NIAGARA MOHAWK POWER CORPORATION

LICENSE NO. DPR-63

DOCKET NO. 50-220

Proposed Changes To Technical Specifications (Appendix A)

FIGURE 6.2.-1

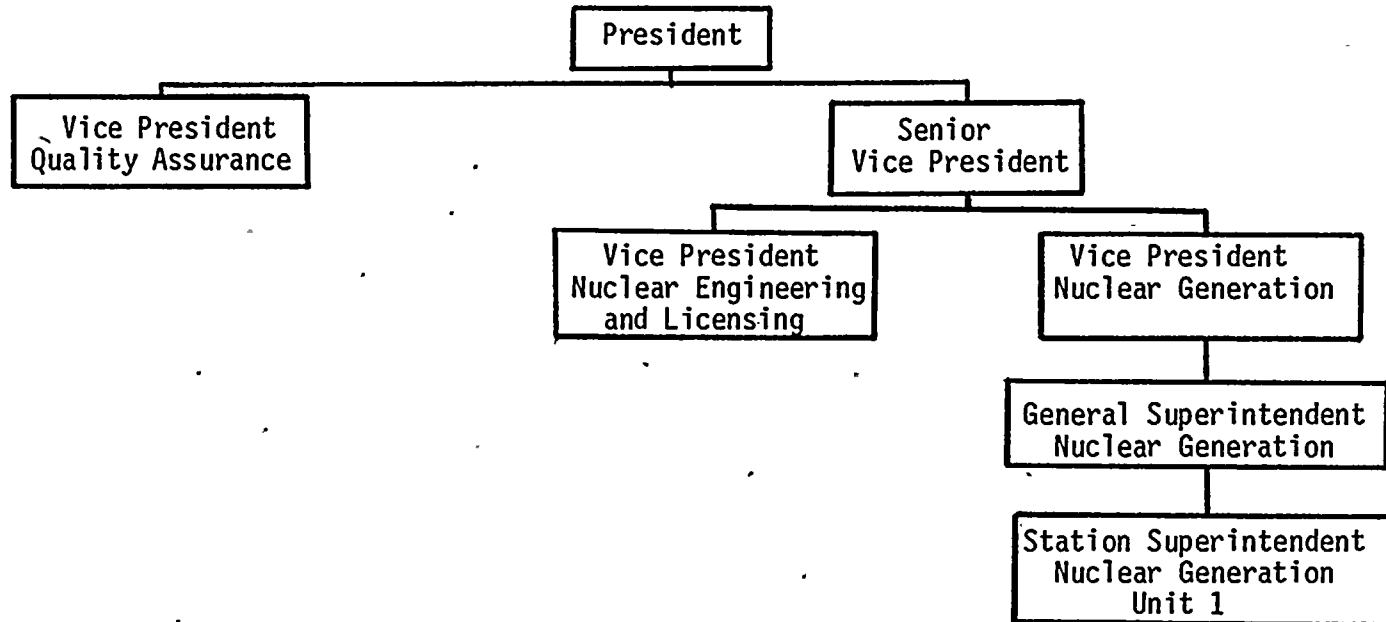
Changes to Section 6.0, Administrative Controls, have been made to reflect the current organizational changes, the current audit frequencies of the Facility Emergency Plan and Security Plan and the current radiation protection requirements with regards to High Radiation areas at Niagara Mohawk with respect to Nine Mile Point Unit 1.
